## **VILLAGE OF DOBBS FERRY BOARD OF TRUSTEES AGENDA**

**RE:** 417 Broadway

**RE:** Site Plan Review  
417 Broadway – Sacred Heart Church  
Village of Dobbs Ferry

SHEET L-1

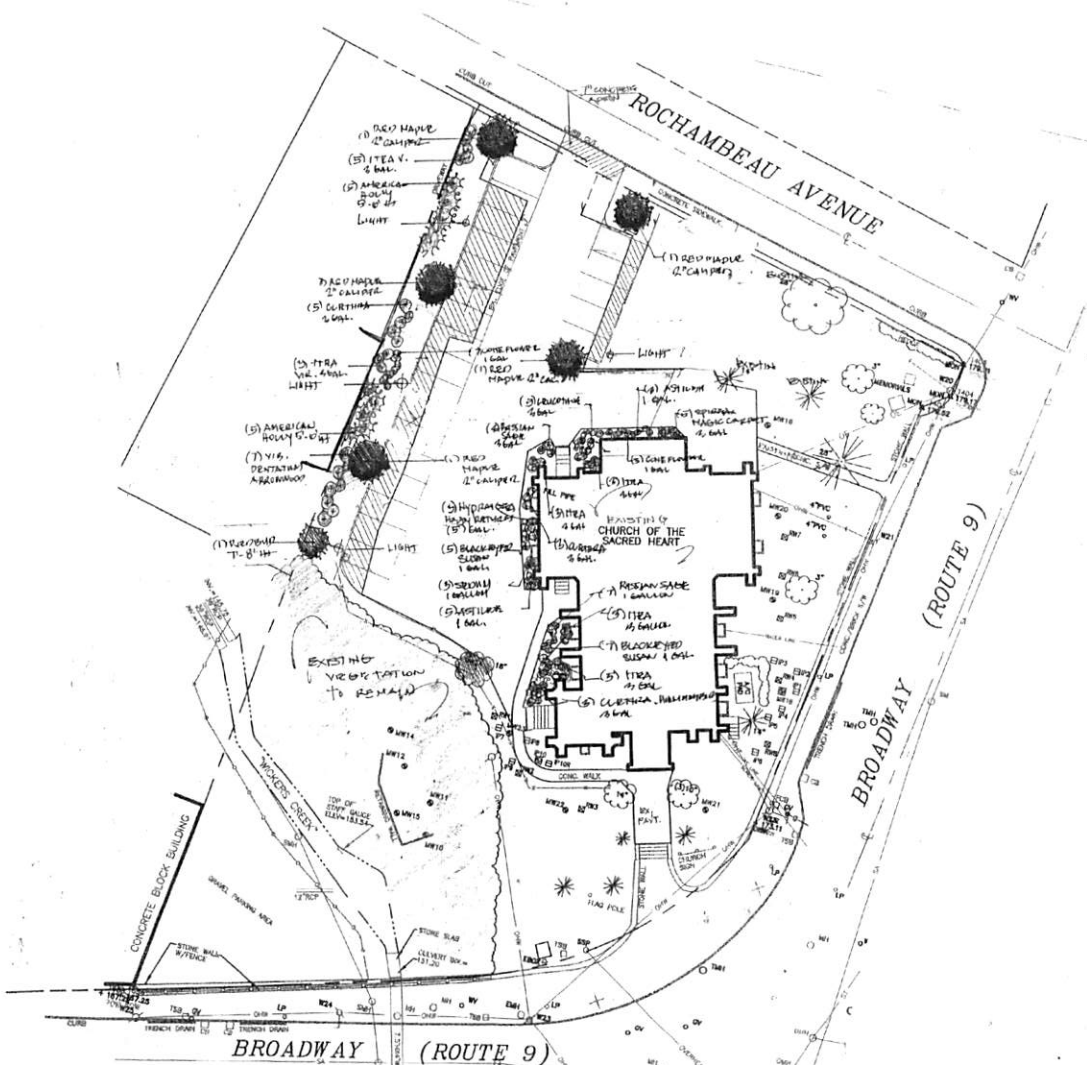
1. **Parking.** The Applicant is proposing to repave and repaint the existing parking lot, as well as add two (2) cobble curves. The Project will add additional parking spaces. It is noted that in recent aerial photographs it appears that cars are already utilizing the grass area as parking spaces. The proposed site plan would improve the current parking situation. The site plan should be updated to include the dimensions of the parking spaces, parking aisle, and curb cuts. Standards for parking lots can be found in §300-48(D) of the Zoning chapter.

2. **Lighting.** The Applicant provided a lighting plan. The Applicant should also provide lighting details. All lighting must comply with §300-41 of the Zoning chapter.

1. Provide dimensions for all parking spaces and aisle widths.

2. An erosion and sediment control plan and details must be provided.
3. Calculations verify the sizing of cultec units must be provided for the increased impervious areas proposed. Clarification with regard to an overflow or outlet to the detention system must be detailed as the design states infiltration is not being considered.

4. Test pits must be performed to confirm soil type and to determine the elevation of ledge rock and groundwater prior to construction.
5. Provide a minimum of an 18" sump at the proposed drain inlet for water quality.

6. Indicate existing and proposed topography to confirm positive pitch to the proposed drain inlet.
7. The existing driveway may be used as a construction entrance. Add the following note to the plan, "The paved street adjacent to the site entrance shall remain clear and will be swept daily to remove an excess dirt, mud or rock tracked offsite."

8. Details for the proposed cultec system should include:
  - a. Actual configuration of system.
  - b. Include at least one inspection port per row of cultecs and include in the details.

- c. Provide all rims, inverts and sump elevations for any proposed piping and the proposed detention system.
  - d. Provide manufacturers details required for installation in paved areas.
